Stormwater Pollution Prevention Plan Inspection Report

Project Name and Location: Blackwell

Problem Areas/Special Observations (Note problem areas ONLY below):

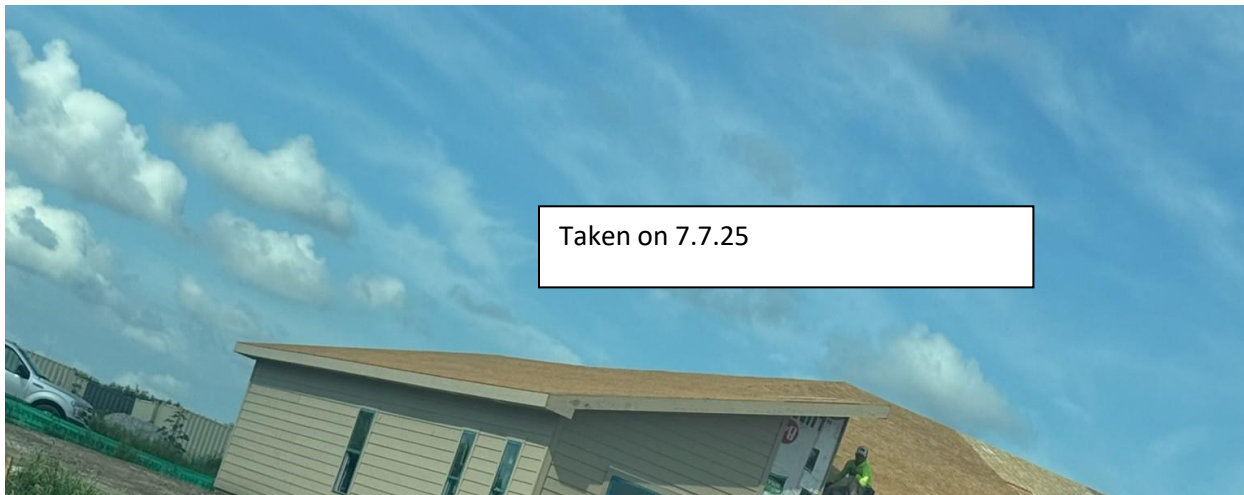
BMP	Location	Observation, Effectiveness, & Corrective Actions Ordered
Stabilize	In-active	Stabilize all areas that have been inactive for 14+ days- Weeds are not considered vegetation.
Stabilize	Swale	Stabilize swale on North end as soon as possible if work is done
Stabilize	Detention Ponds	Stabilize detention ponds asap- weeds are not considered vegetation
Silt fence	Detention Pond	Reset silt fence along detention pond behind Residences
Rock	Access Rd/Const. Entrance	Need more rock at construction entrance
